MEMORANDUM

TO: Planning, Housing, and Economic Development Committee
FROM: Glenn Orlin, ^{GO}Deputy Council Staff Director
SUBJECT: Chevy Chase Lake Sector Plan—fiscal and economic impact; transportation issues

SUBJECT: Chevy Chase Lake Sector Plan

SUBJECT: Chevy Chase Lake Sector Plan

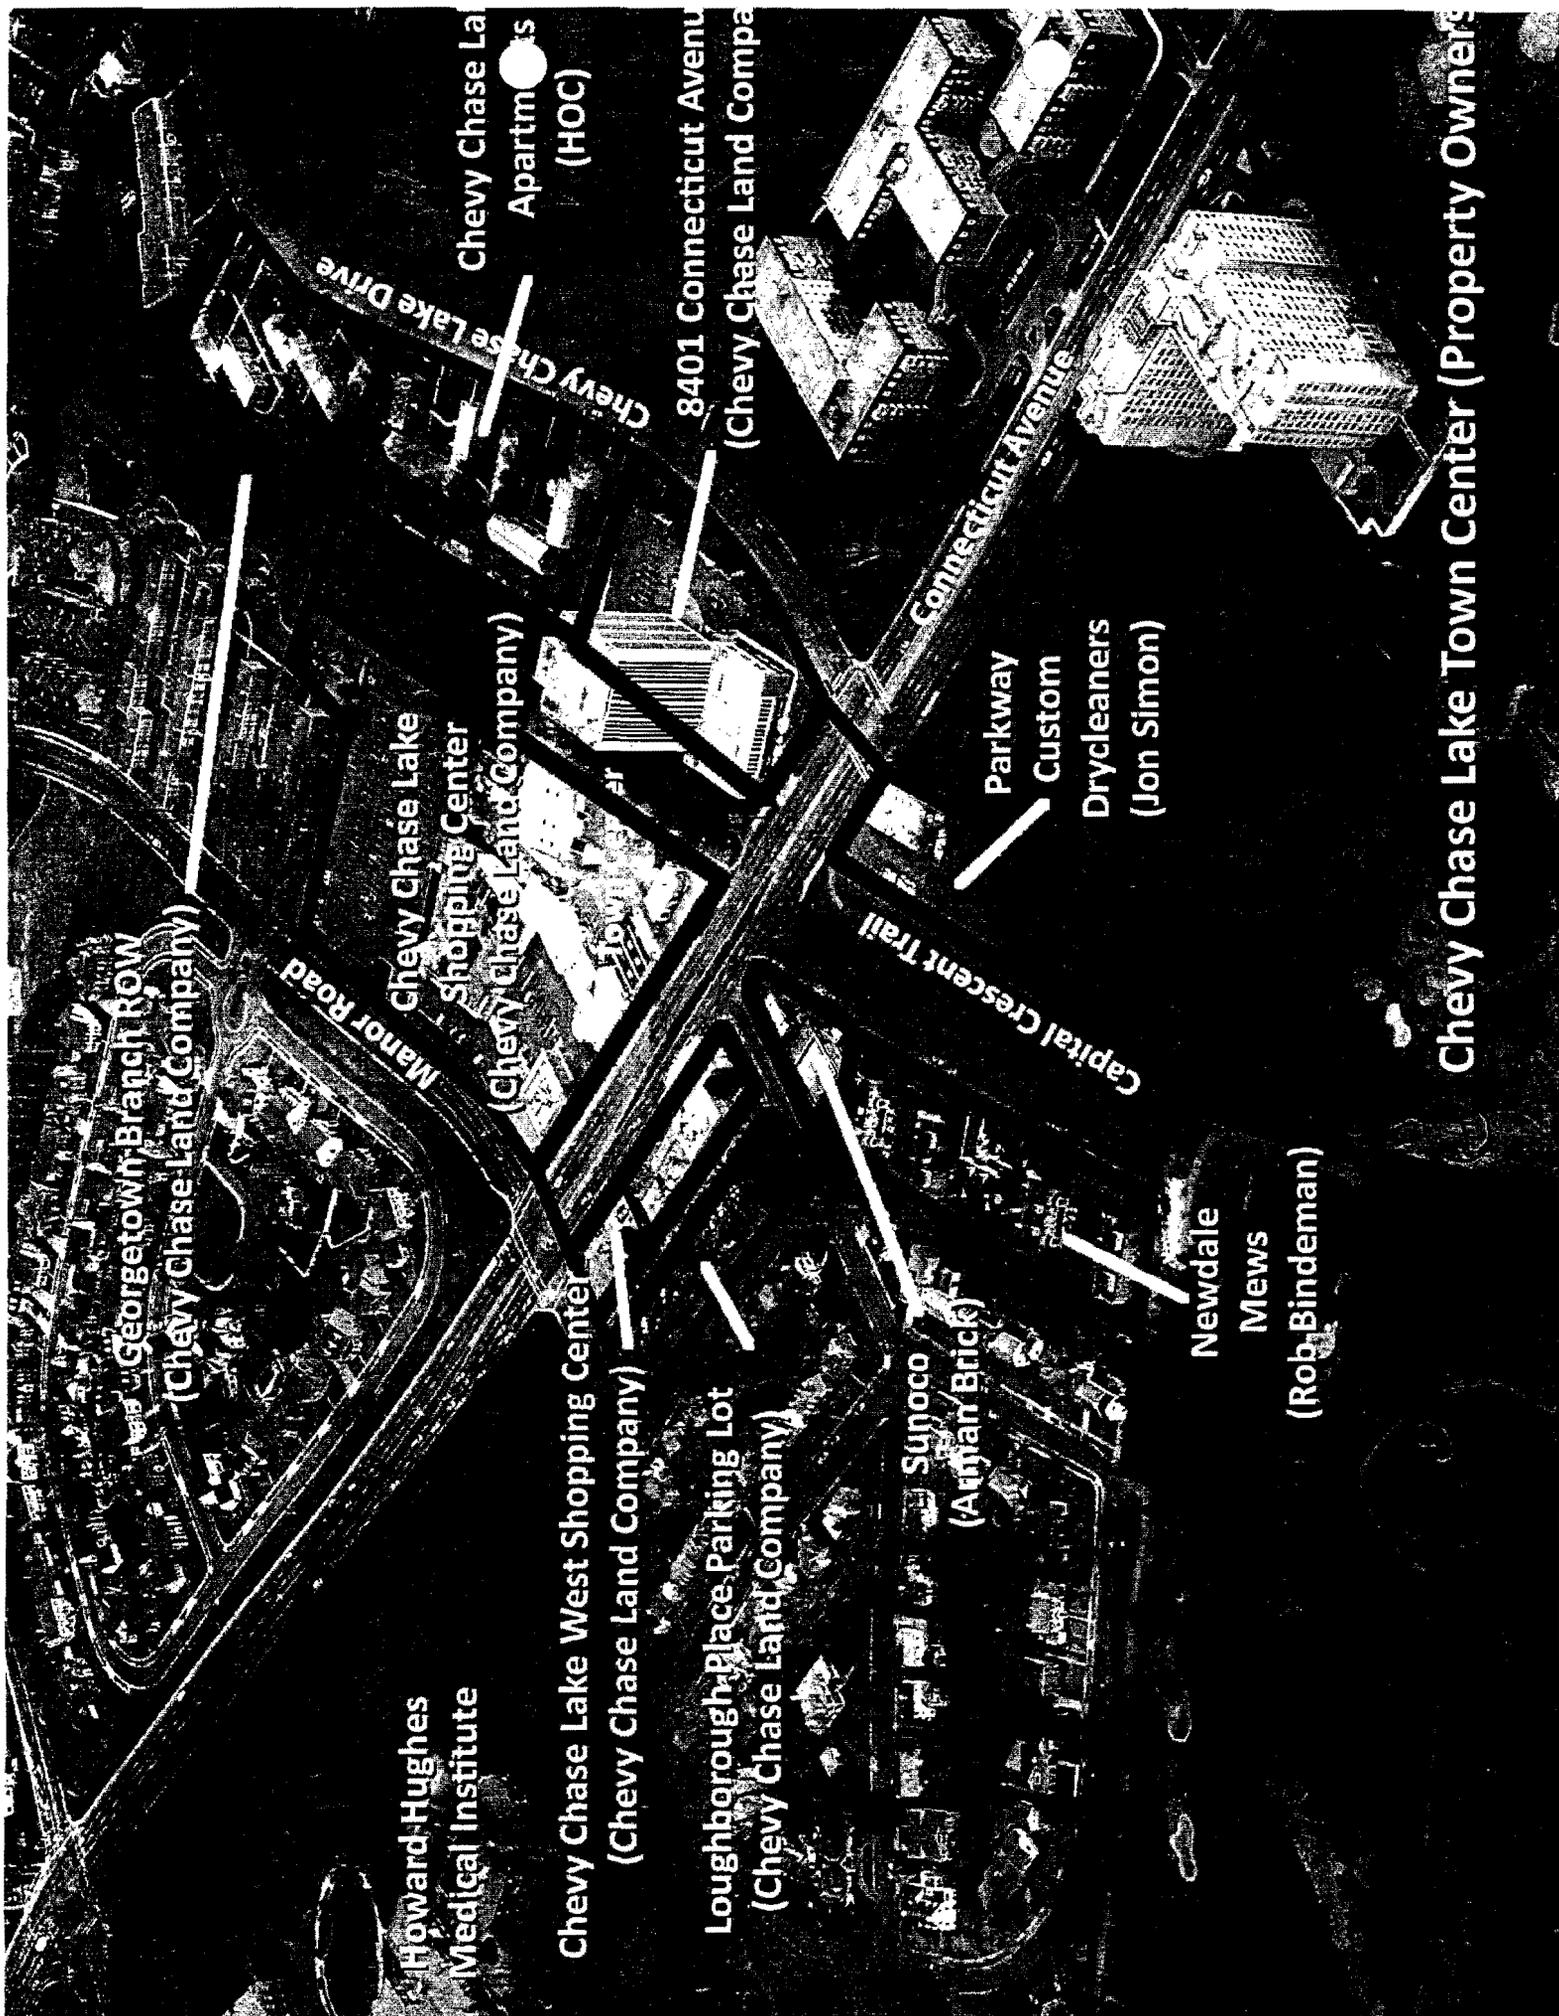
How much commercial density is required on the site to accommodate the 74,356 sf. of office space and 174,016 sf. of retail uses included in the approved subdivision plan for the site?

The shopping center site has a gross tract area of about 375,000 sf. To accommodate the 248,372 sf. of commercial uses included in the existing approved subdivision plan, new zoning must have a minimum commercial FAR of 0.67. The two zones the Planning Board recommended for site allow a maximum commercial FAR of 1.0 and 2.0.

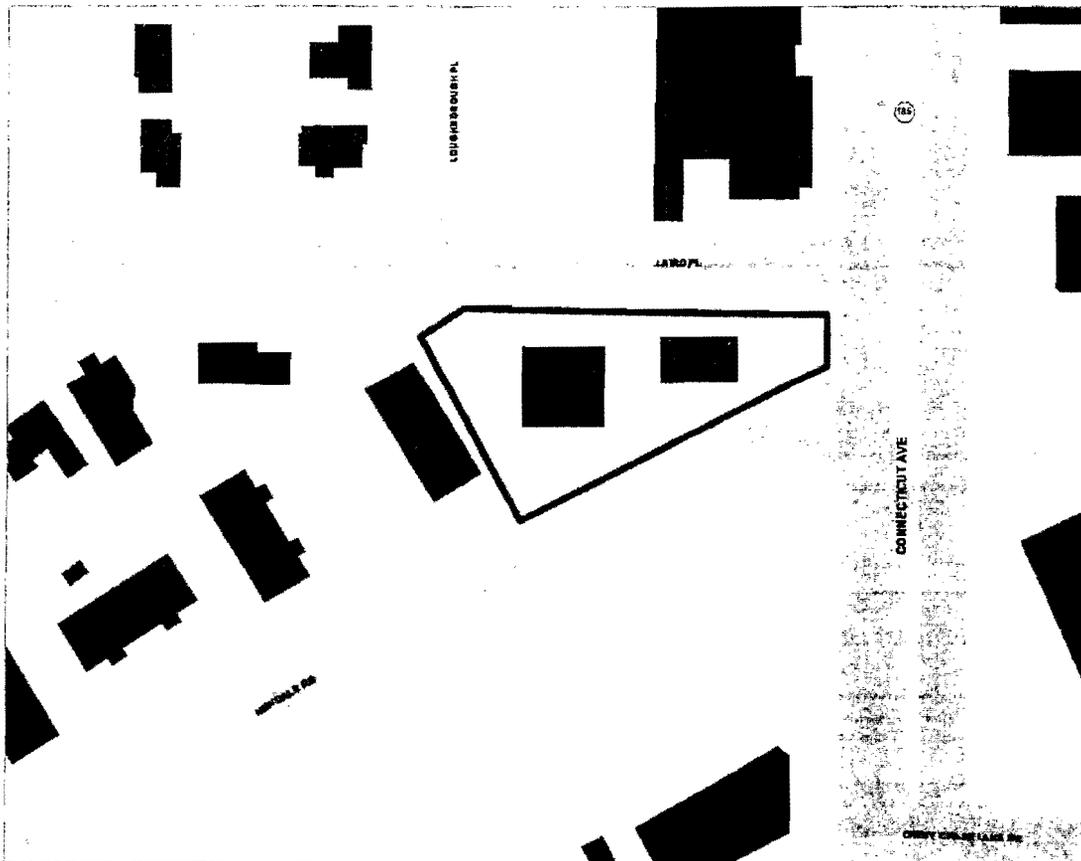
Is there a way to ensure that sufficient foliage will either be retained or newly planted to act as a buffer to the existing neighborhoods?

The Planning Board's recommendation in the Sector Plan for this property emphasizes that an "essential part of redeveloping this site will be to maintain compatibility with the single-family homes to the north. Particular attention should be paid to solar access and shading, as well as maintaining and extending building setbacks from the existing homes, vegetative screening, and view corridors between the buildings." (p. 36) The draft Design Guidelines contain recommendations for the green buffer between new buildings and the existing homes, which encourage the retention and protection of existing trees and the planting of an expanded green buffer in terraces along the property line, among other guidance. (p. 59)
